TO: All Potential Bidders
FROM: Purchasing
RE: RFP No. 372 – Phase V Contact Water Controls Q&A Memo No. 1
DATE: October 20, 2026

The following questions were received in writing prior to the deadline, concerning the above-referenced RFP, and the responses are provided below for the benefit of all potential respondents.

PERIMETER ACCESS ROAD FIGURE

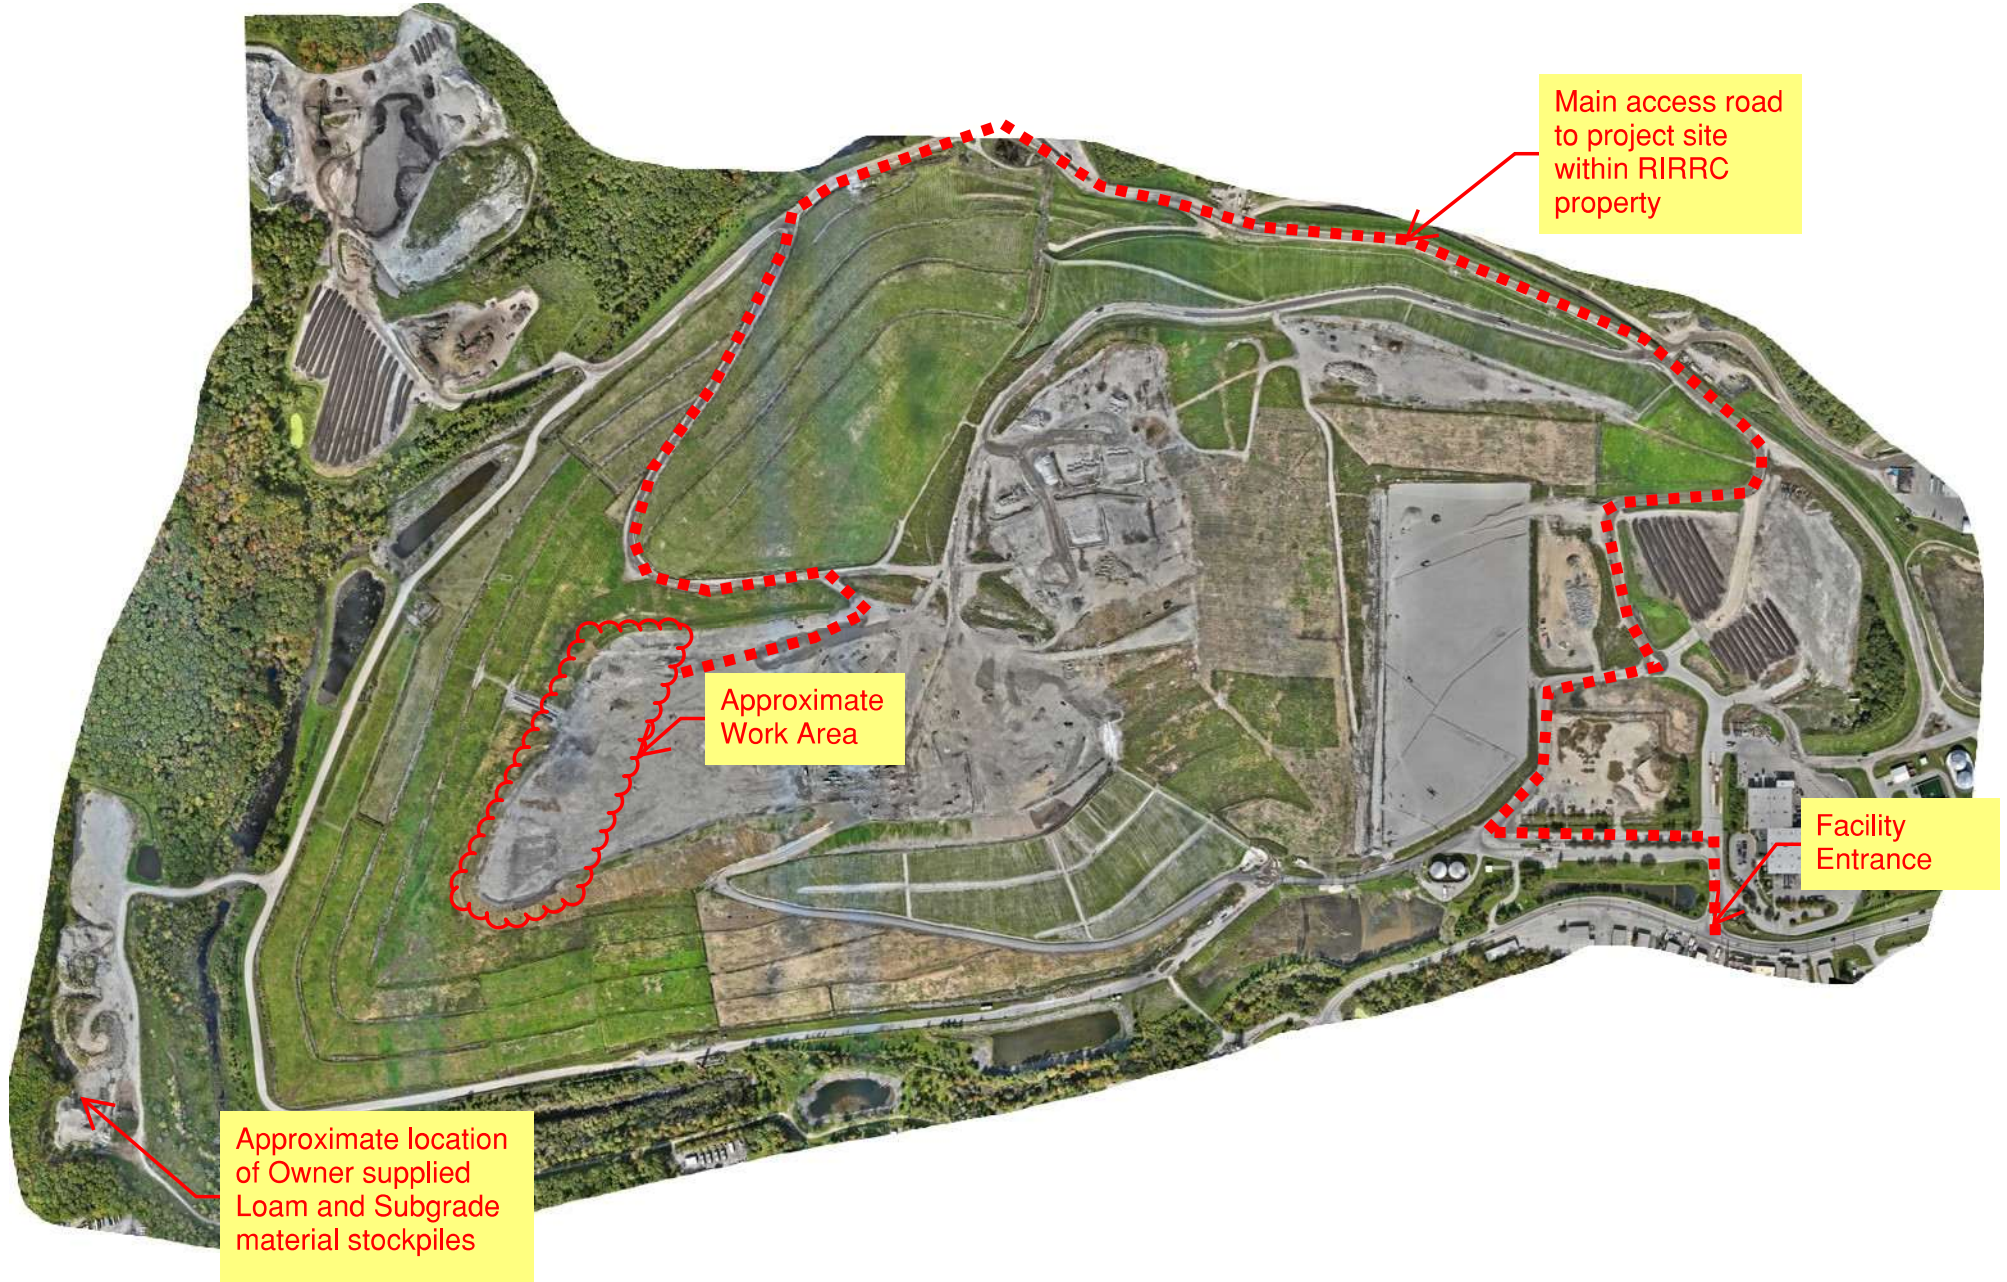
Q9.) “Provide location (or approximate distance) of Owner supplied subgrade/common fill to the Project location.”

Q13.) “Provide main access road to the project site.”

Answer: Owner supplied subgrade/common fill is located on site. The approximate travel distance is 1 ½ miles (one-way). See Attachment No. 2 for approximate location.

Answer: See Attachment No. 2.
